Springdale Solar Farm

Amendment Report

29 May 2020

**FIGURE 1.1
LAYOUT AMENDMENTS**

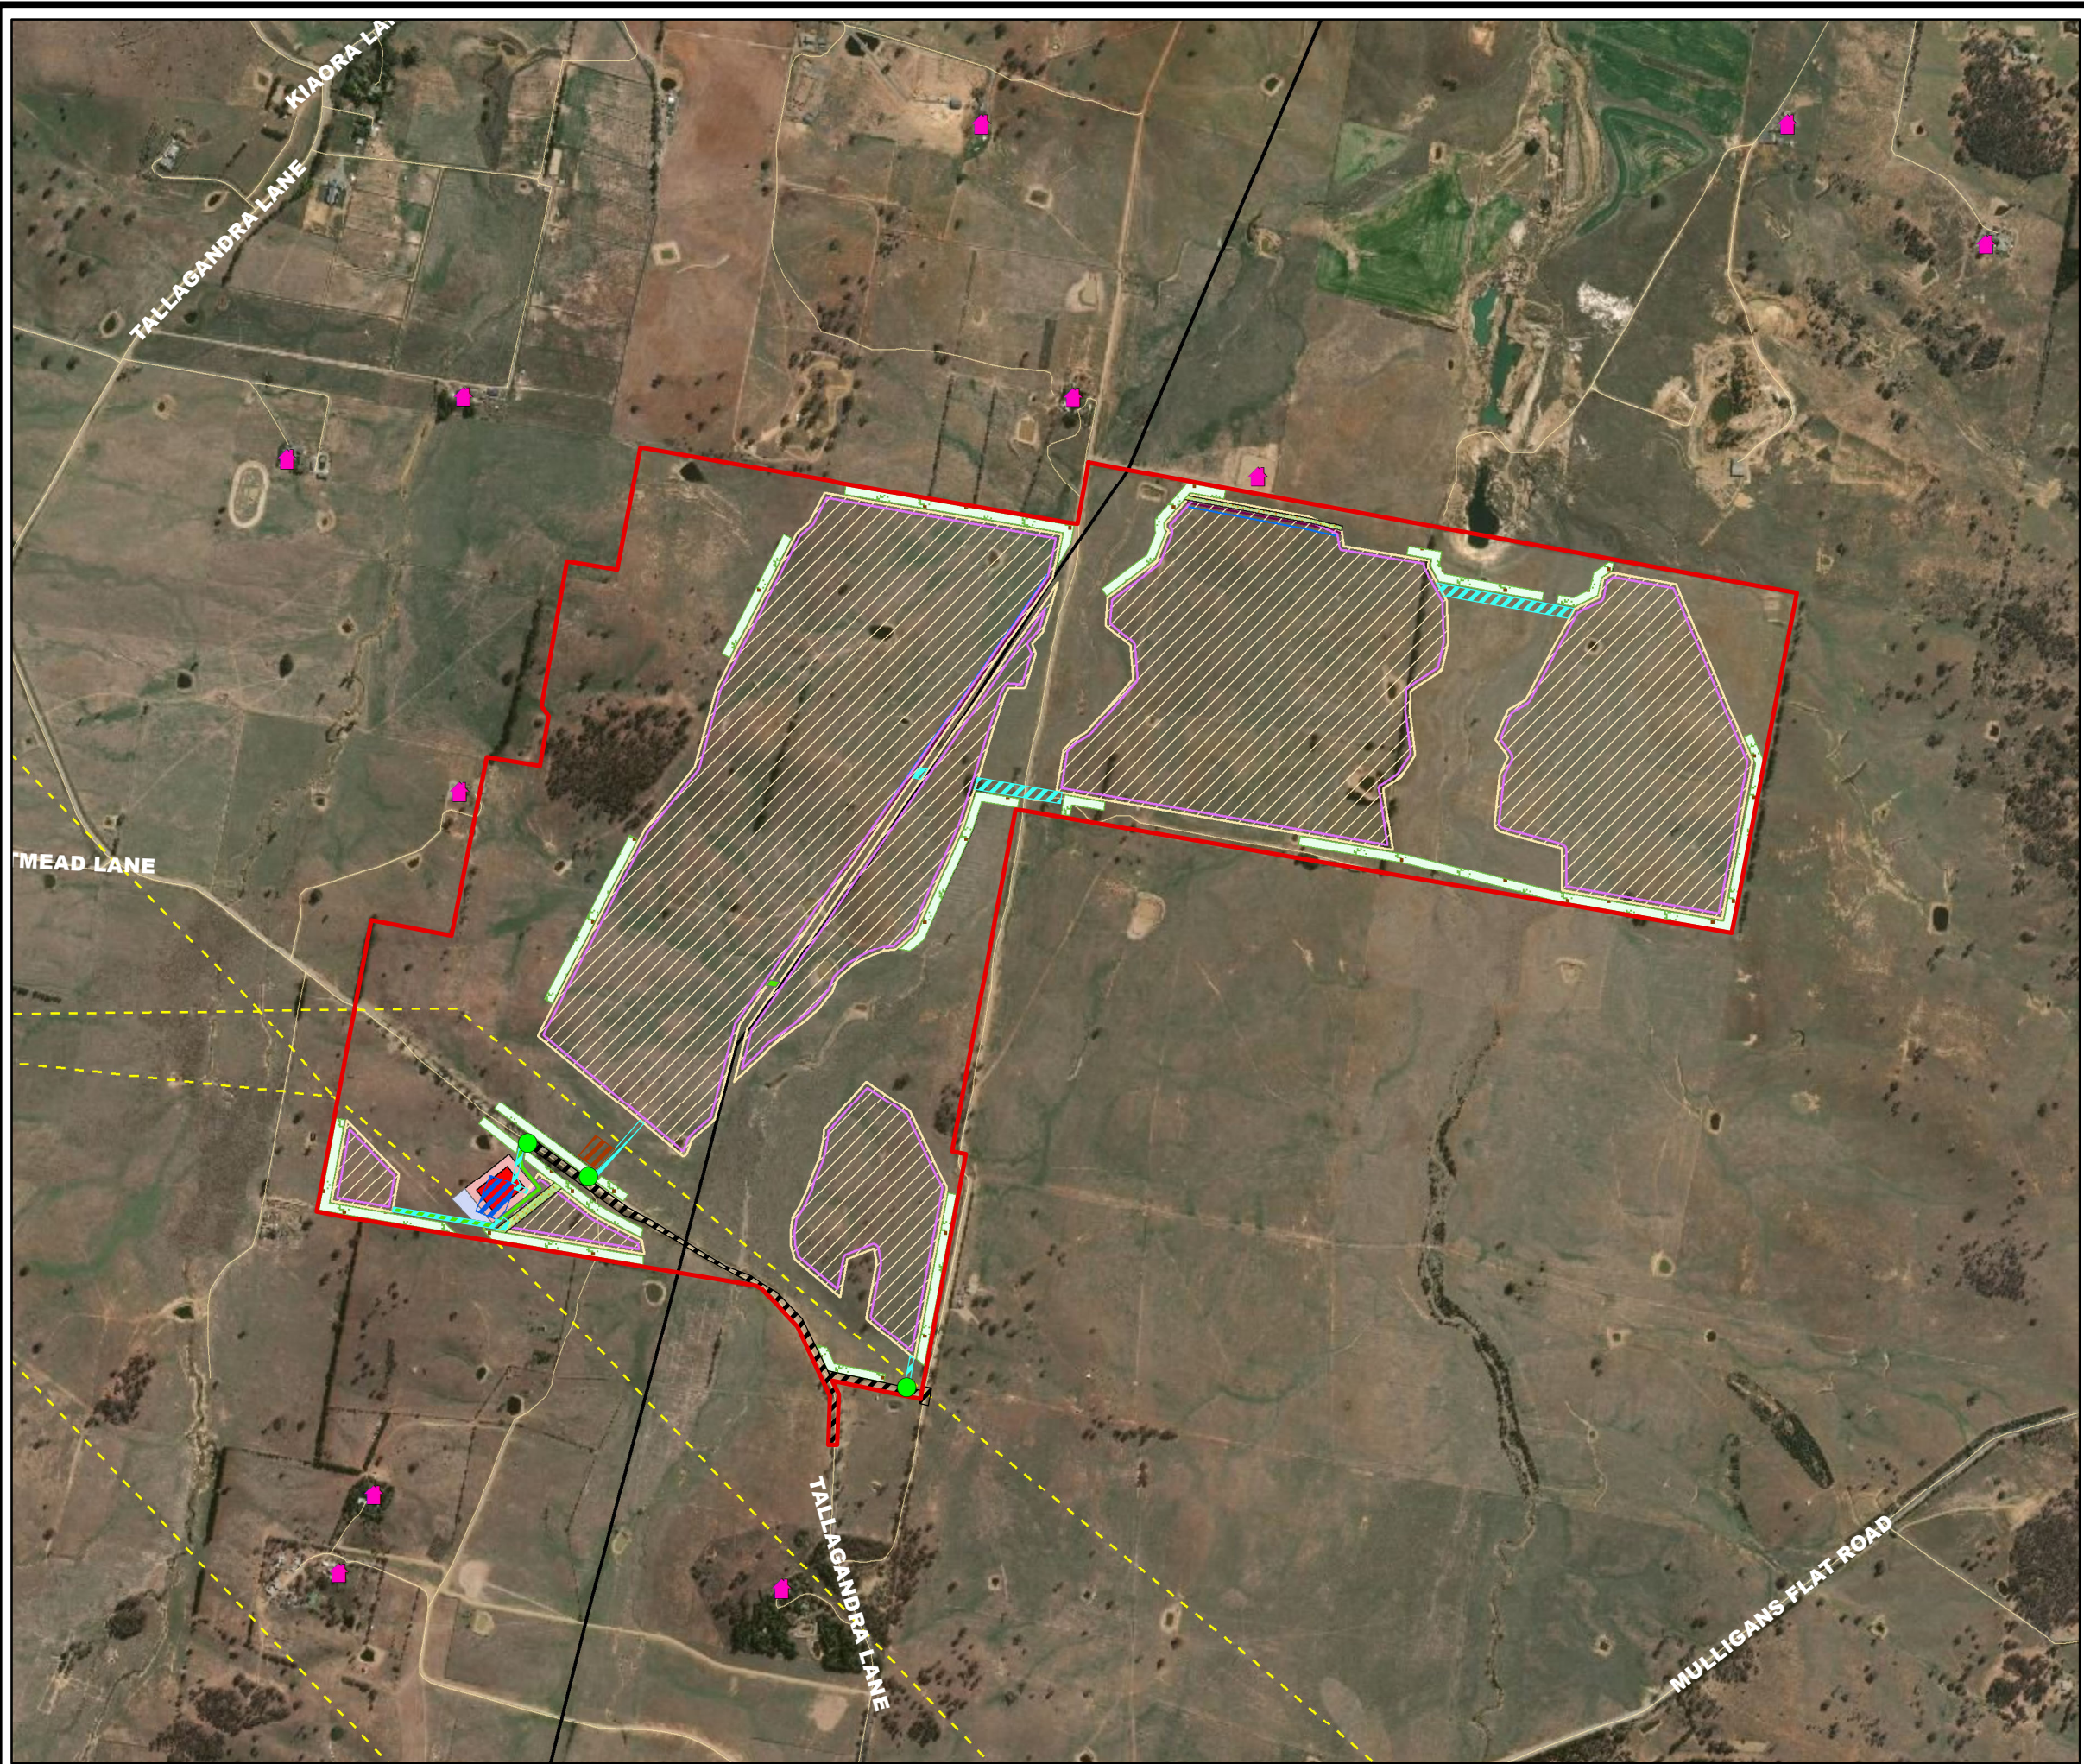
This Amendment Report considers a number of proposed design refinements, shown on Figure 1.1 and comprising the following:

- **Removal of one development area** – one block of solar panels in the south eastern part of the site, to the south of Tallagandra lane, would be removed from the project design
- **Springdale Solar farm substation** - the solar farm's substation would be reoriented within the same location and an asset protection zone (APZ) would be included, as per TransGrid requirements. The associated subdivided lot will increase in size accordingly

- **Internal access tracks** – internal access tracks would be slightly realigned, with one additional access track crossing of the gas pipeline
- **Adjustment of one development area footprint and extension of screening vegetation** – The footprint of one development area would be relocated slightly south of the northern boundary of the Site to allow for the screening vegetation to be extended without impacting on any mapped Golden Sun Moth habitat
- **Extension of operational period** - the operational lifetime of the solar farm would be extended from 30 years to 35 years.

Figure 2.1 Northern development area showing previous extent and proposed amendments

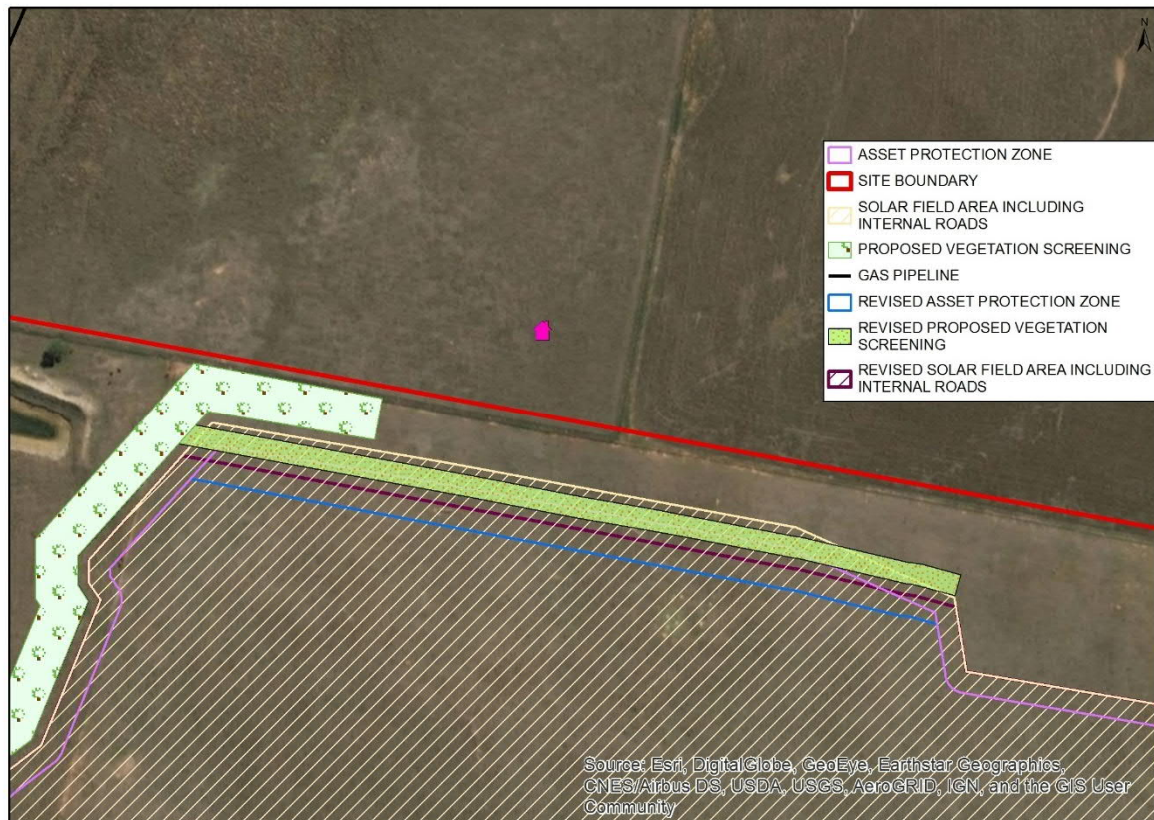
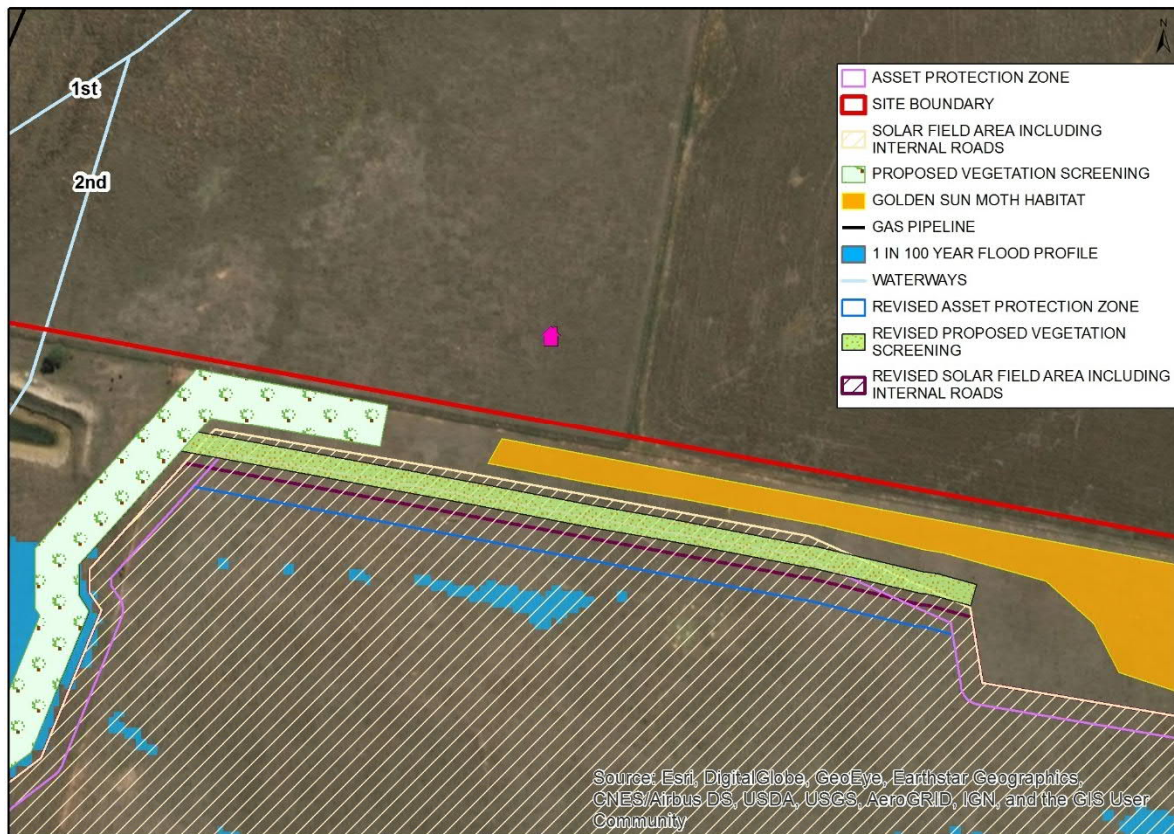
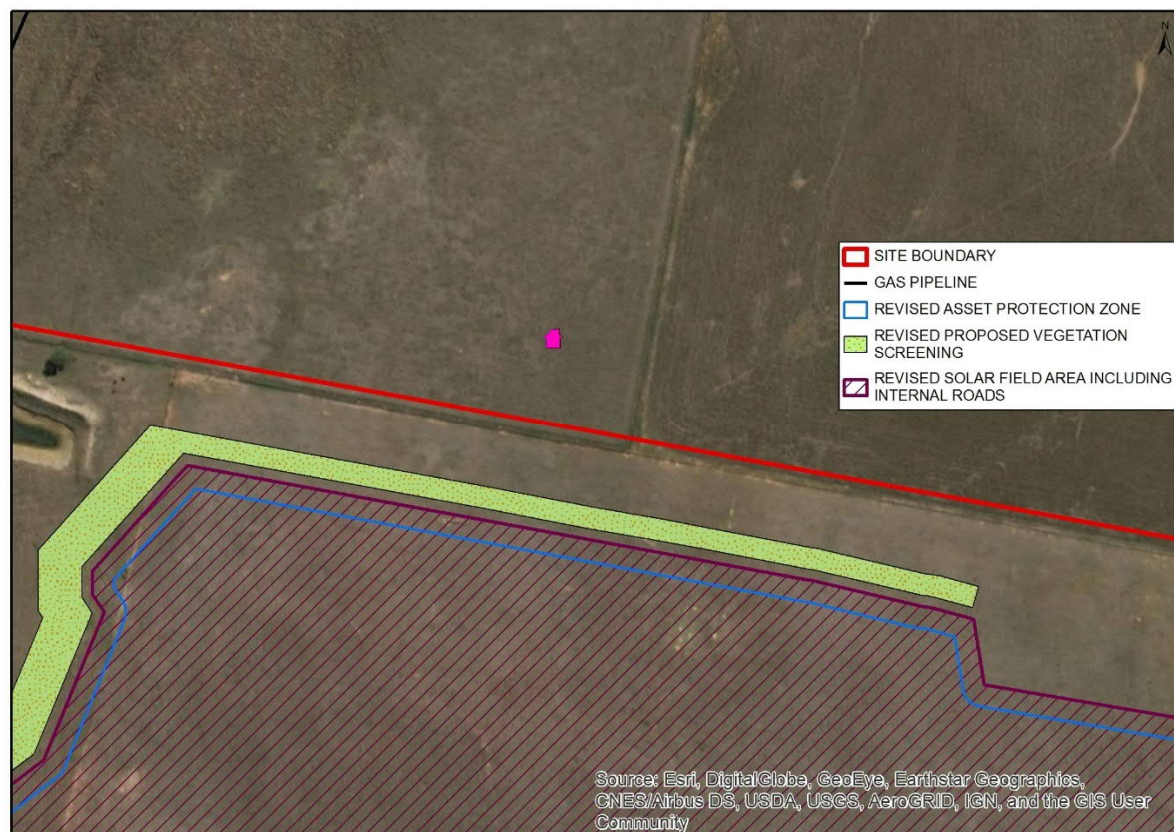
Since the public exhibition of the project, a new private residence has been developed on land located immediately north of the Site boundary. As this is a new dwelling that was constructed following the public exhibition of the EIS, the potential for visual impacts from the project was not assessed for this receptor as part of the original Landscape and Visual Assessment (LVIA). As such, the proponent has addressed the impact to this receptor within the LVIA addendum report which supports the RtS.

- A reduction in the extent of the developable area adjacent to this receptor, drawing back the development footprint approximately 20 m to the south, creating a gap of approximately 50 m between the nearest receptor and the solar array
- An extension to the proposed screening vegetation to the east, passing to the south of the existing golden sun moth habitat area along this northern boundary of the Site. This screening vegetation would be 10 metres in width and would extend approximately 300 metres further to the east beyond its previously proposed extent (see Figure 2.1, Figure 2.2 and Figure 2.3).

Figure 2.4 Amended layout of substation and southern development area showing development constraints

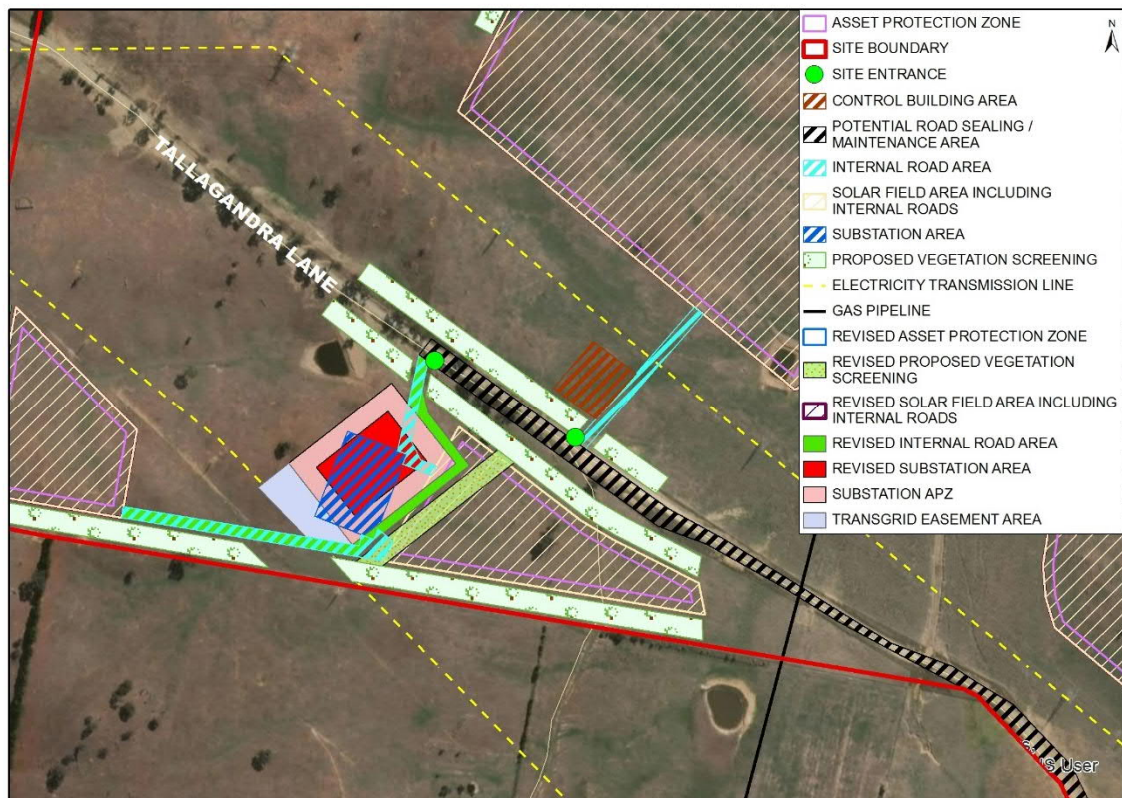
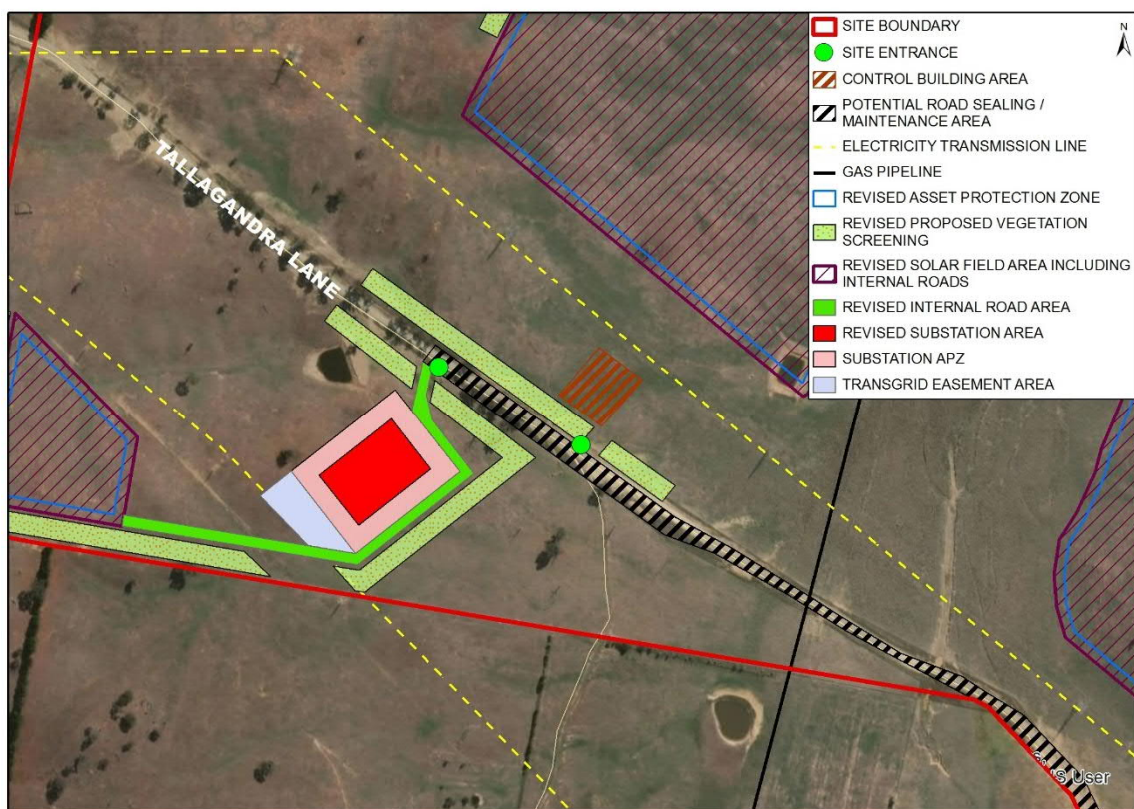
Based on the feedback received from key stakeholders and ongoing design refinement, an opportunity has been identified to further reduce the potential environmental and community impact of the project. In this case the location and size of the Springdale Solar Farm substation has been revised as follows:

- The APZ for the substation will be increased in response to inputs received from TransGrid
- The substation would be slightly reorientated to avoid the APZ encroaching on existing Golden Sun Moth habitat
- As part of the realignment, the substation would be relocated slightly north of its indicative location described in the EIS.

The size and location of the electrical switchyard would not change, nor would the connection assets located within the electrical switchyard and substation. The provision of facilities for workers, including a control room, workspaces and toilet(s) would also remain the same. As the substation would be constructed within the switchyard, the combined footprint would remain approximately 50 m x 90 m, with the facility remaining within the same location. Lot 209 DP754908 would still be subdivided to create three new lots to facilitate the substation, though the main substation lot would be larger than previously provided (see Figure 2.5 and Figure 2.5).
